Device	C515C-8R, C515C-L
Marking/Step	Step AA
Package	P-MQFP-80

This Errata Sheet describes the deviations from the current user documentation.

- C515C User's Manual 11.97
- C515C Data Sheet Feb. 2003
- Instruction Set Manual 07.2000

**CAN.3: Description in User's Manual regarding the reception of remote frames and the data length code (DLC) field is incorrect**

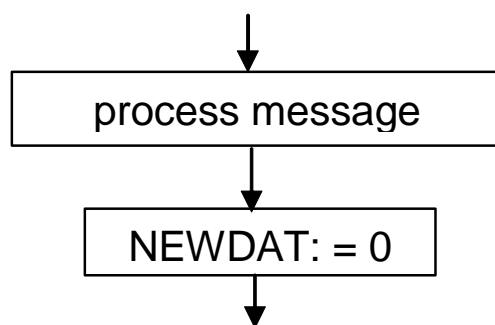
It is inaccurately described in the User's Manual on page 6-94 under '*Arbitration Registers*' that '*When the CAN controller stores a remote frame, only the data length code is stored into the corresponding message object*'. The correct should be that the DLC field remains unchanged in the receiving message object, and that the CPU has the responsibility to define the DLC of the answering data frame.

This correction will be updated to the future versions of the User's Manuals.
